1. INTRODUCTION

This Design and Access Statement Addendum has been prepared by the Lead Designer, Carbogno Ceneda Architects, and should be read in conjunction with the following documents submitted as part of the application:

FIG 3 - **PROPOSED** - New configuration showing 600mm piles to the north of the existing pads and linear reinforced concrete wall to the south inside the consented extension to the existing plantroom off Barrie House.

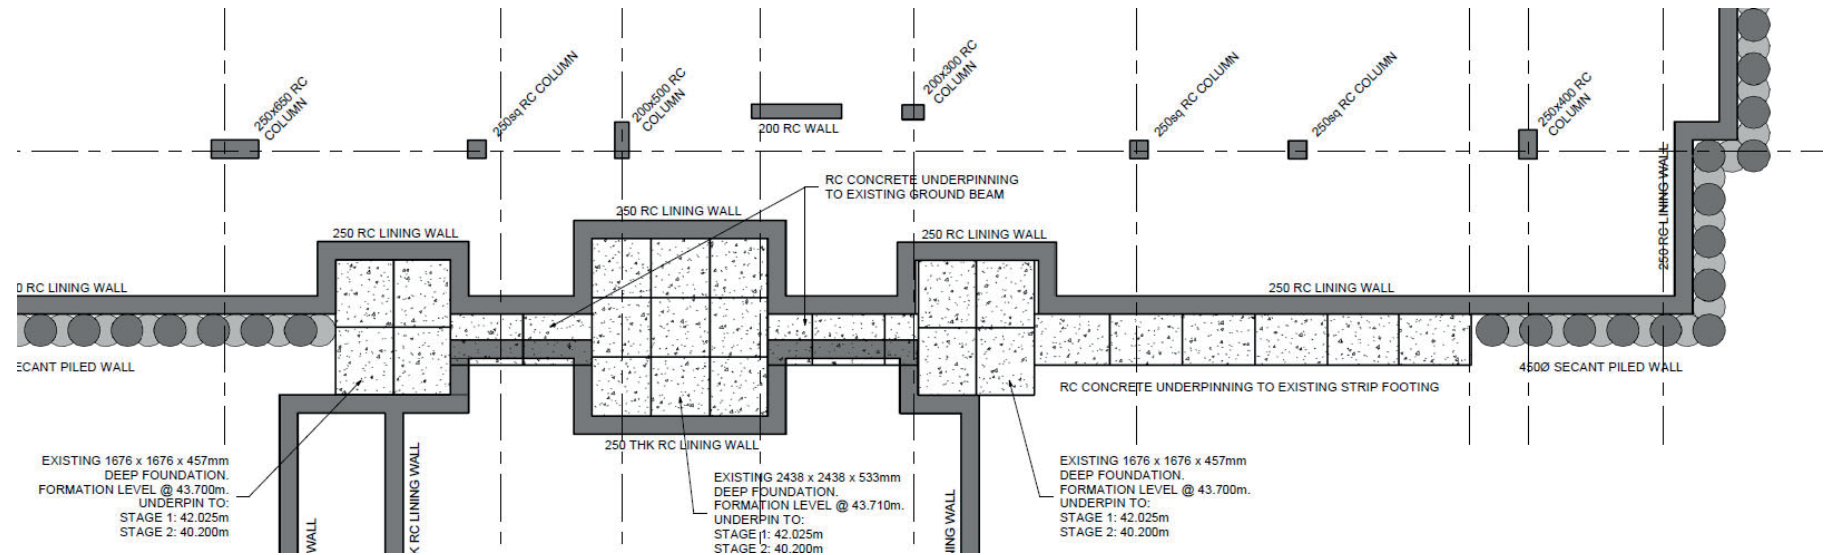
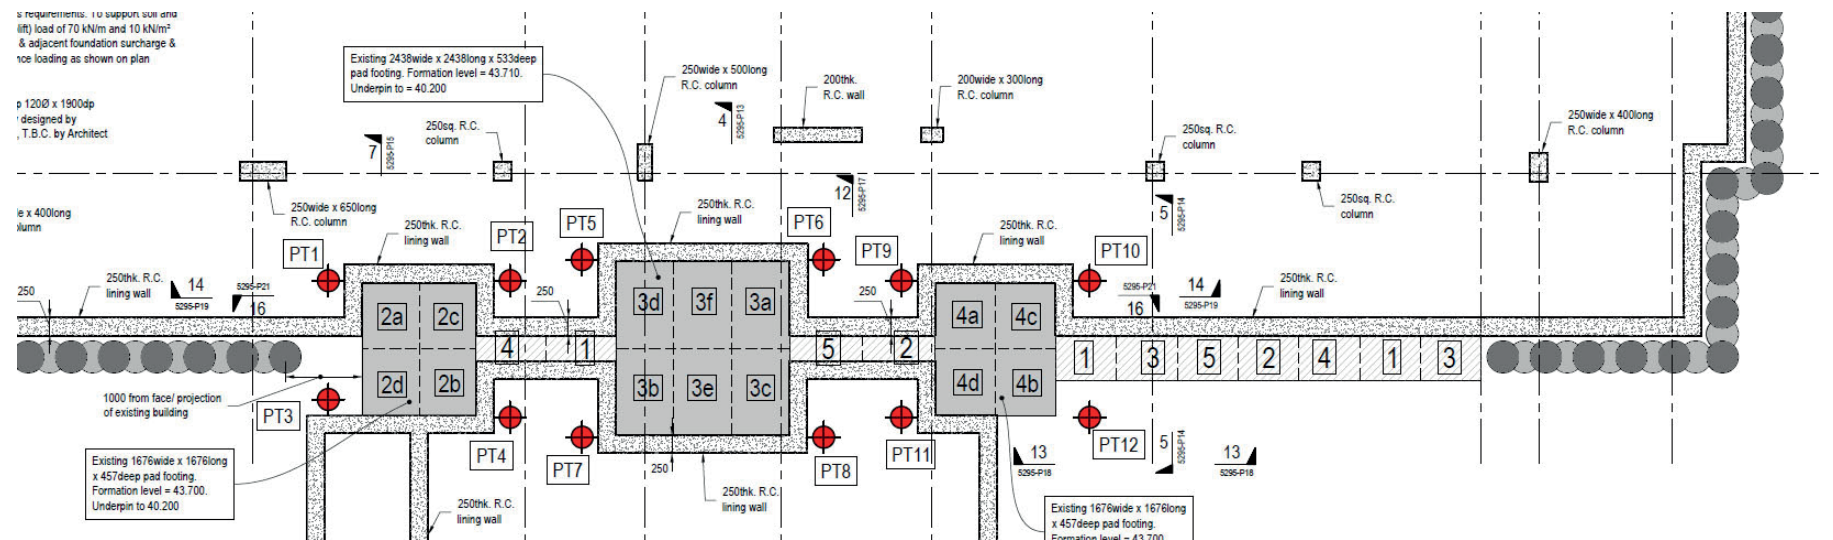
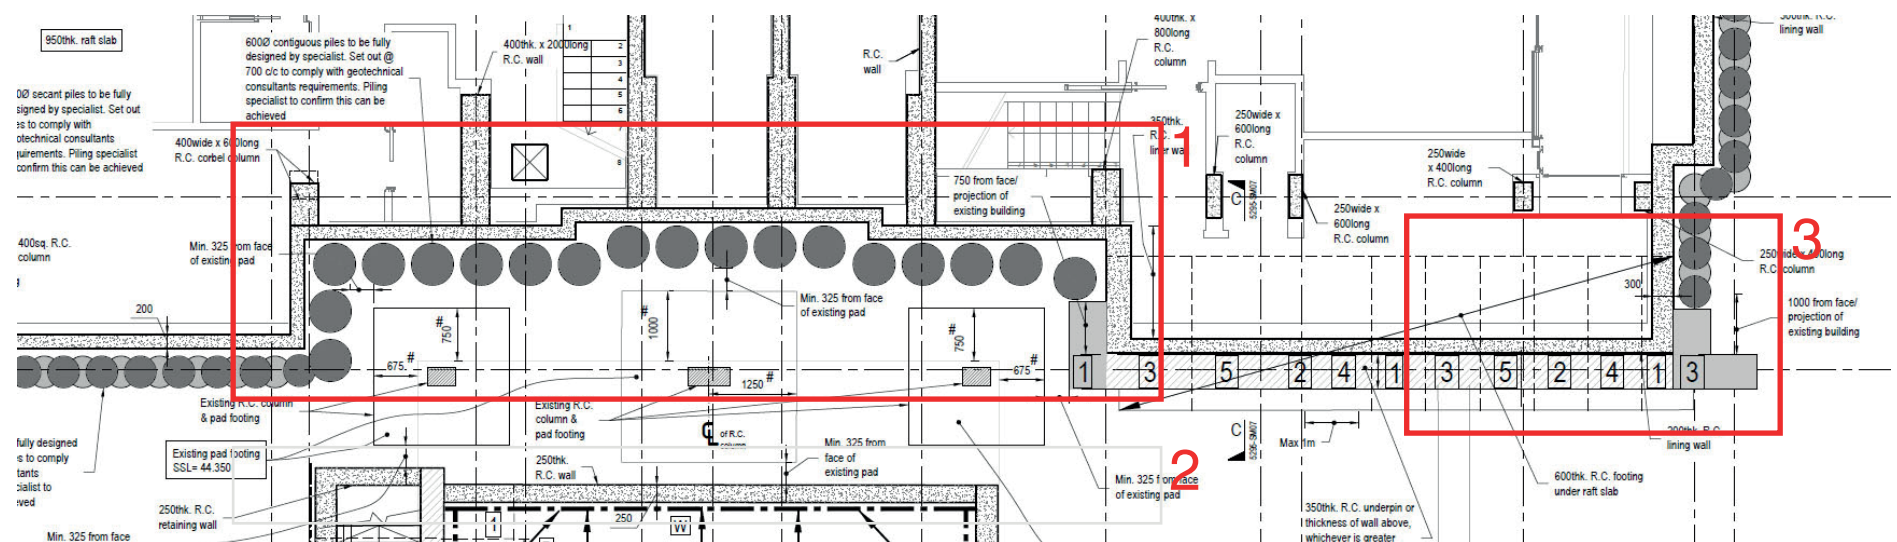
Since the planning permission was granted, the new Applicant has undertaken detailed design development ahead of the construction of the approved scheme. This detailed design analysis has included further structural assessment, and geotechnical analysis of ground conditions and of the pad foundations. This detailed analysis has established that the main pads of the existing building are on maximum stress and therefore the proposed underpinning works risk structural impact to the existing building due to movement.

An initial solution was devised by CGL in collaboration with Richard Tant Associates and this detail was submitted to discharge the S106 Obligation for a Detailed Basement Construction Plan (Para 4.4) which was approved on 31st July 2023. Following further technical assessment it was found that this solution would have led to the demolition of part of Flat 1 on the ground floor of Barrie House as it would require the formation of additional mini piles under the existing building to temporarily brace the pad for stability during the formation of the double underpinning.

This led to the conclusion that 600mm diameter piles should be formed to the north of the existing pad foundations to act as a retaining wall as shown on the current proposal. The double underpinning in this instance is to be omitted. The proposed piles are drilled into the ground and do not generate a high level of vibration and will not disturb the existing pads. In order to further minimize the vibration in this area the proposal is for contiguous piles to be in this part of the building.

As part of the structural design development, the internal concrete lining inside the Lower Ground Floor at Barrie House is proposed to be cast in a straight line. This will also act as a retaining wall for the pads from the south side. Due to the shallower structural slab level within this plant room, the loadings imposed to this part of the building are substantially lower than those imposed on the north where the proposed piles will.

A minor additional alteration to the party wall foundations/piles at the rear of Barrie House includes the proposed additional underpinning to support the existing wall at the rear of Barrie House (see Fig.3 item no.3).

- 1 - Proposed 600mm diameter piles to main basement
- 2 - Proposed linear reinforced concrete wall to plant rooms
- 3 - Proposed underpinning and ground floor garden wall

FIG 2 _ PROPOSED _ Lift position - Ground floor plan

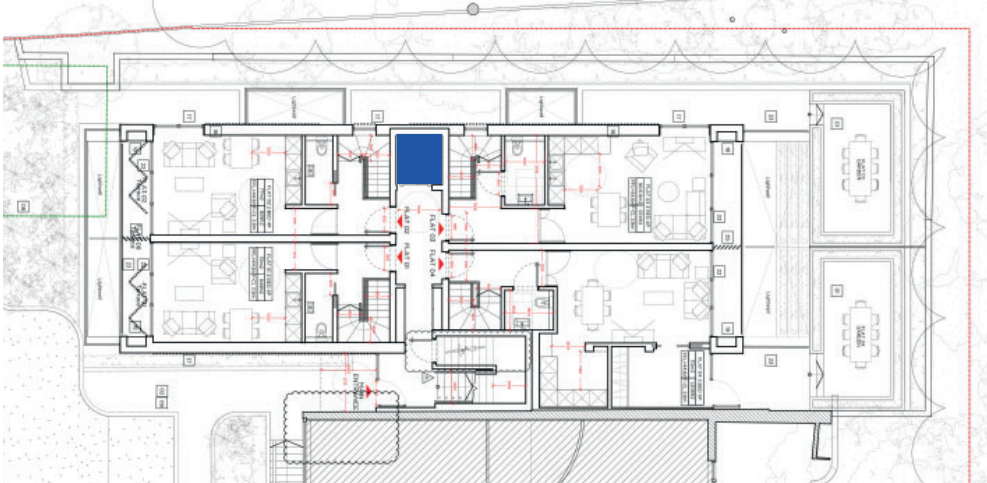
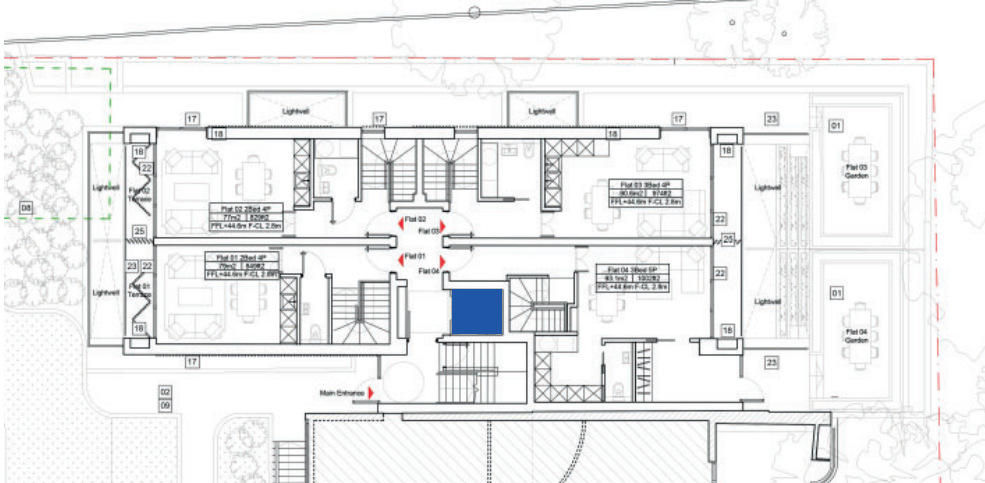
As part of the overall structural proposal, the lift position is also being amended. The lift core originally located on the northwest elevation in the consented scheme, is now proposed next to the main staircase.

The reason for this alteration is partially led by structural reasons related to the position of the piles in the basement in relation to the lift core; and partially by the desire to improve communal circulation and access to the flats and to improve the flats' internal layouts, particularly at the ground and basement level within the duplex flats 1 and 4 which are the most affected by the new piling position
